ADA Curb Ramp New Construction Inspection Form (Blended Transition)

NW MAIN ST

24953

NW NORTH AVE

BLENDING TRANSITION (BT)

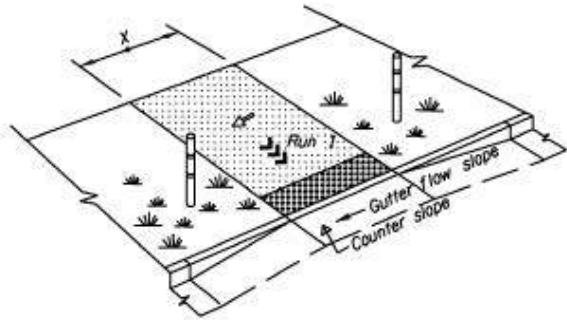
Gutter Flow Slope

2.3

GFS fail workmanship
